UNITED STATES OF AMERICA  
NUCLEAR REGULATORY COMMISSION

In the Matter of )  
 )  
DUKE ENERGY FLORIDA, LLC ) Docket Nos. 52-029 and 52-030  
 )  
(Levy Nuclear Plant, Units 1 and 2) )

NRC STAFF RESPONSES TO COMMISSION PRE-HEARING QUESTIONS

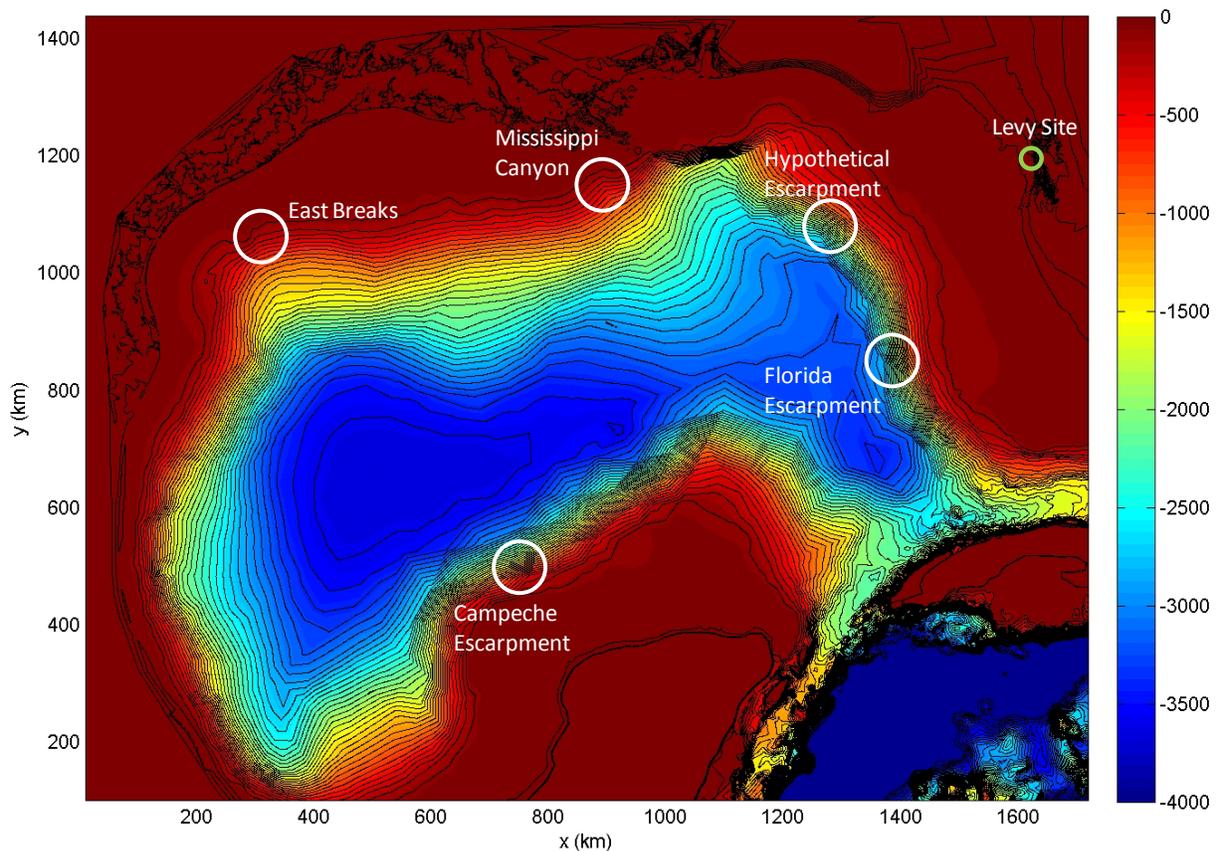
1. **In its analysis of seismic seiches, the Safety Evaluation Report (SER) at 2-165 states: "Parameters for the maximum submarine landslide were determined for each of the provinces, except for the Campeche Escarpments where we are awaiting additional data."**

**New escarpment studies have recently been released (e.g., Monterey Bay Aquarium Research Institute, 2013) that map the escarpment in considerably more detail than studies that are reflected in SER Section 2.4. Did the Staff consider the more recent studies and their possible effect on the conclusions in the SER? If so what were the results?**

**Staff Response:** The Staff did not consider the more recent studies referenced in the question. However, the Staff is confident that results from the 2013 multibeam mapping of the Campeche Escarpment have no effect on the conclusions in the SER. This is because the Staff used a very conservative independent tsunami hazard analysis to verify the applicant's probable maximum tsunami results. Since the data needed to develop a realistic estimate of the landslide parameters for the Campeche Escarpment were not available, the Staff developed very conservative estimates of the maximum-potential submarine landslide for the Campeche Escarpment. Specifically, the Staff performed one-dimensional numerical model simulations using a provisional tsunami landslide source located at the Campeche Escarpment to estimate the resulting potential for flooding at the Levy Nuclear Plant (LNP) site. Initial conditions for the landslide source were based on maximum observed landslide parameters along the Florida Escarpment, which is a similar geologic environment. The Staff's analysis for the Campeche source computed the wave runup to stop after progressing 0.6 miles inland. Since the LNP site is 9.6 miles inland, the maximum extent of the tsunami wave does not come within 9 miles of the site.

Similar one-dimensional numerical model simulations were performed for all the potential tsunami sources for the LNP site (See Figure 1). The model simulations employed by the Staff were conservative because they did not account for the radial spreading of the wave and did not account for friction. This approach resulted in conservative estimates of the size and runup of the wave. These model simulations confirmed the applicant's conclusion that the Mississippi Canyon source has the greatest potential to bring the large tsunami wave to the Levy site and was appropriately designated as the probable maximum tsunami source.

The Staff then conducted independent confirmatory two-dimensional model simulations for the Mississippi Canyon. The Staff's tsunami model simulations employed modeling assumptions that included additional conservativisms not included in the applicant's model, such as assuming that the entire submarine landside volume 'slumps' instantaneously and into a large mass on the seafloor. The Staff's model produced results that showed the probable maximum

tsunami estimated by the Staff (20 ft) or the applicant (12.94 ft) would not reach the LNP site (site grade of 51 ft).
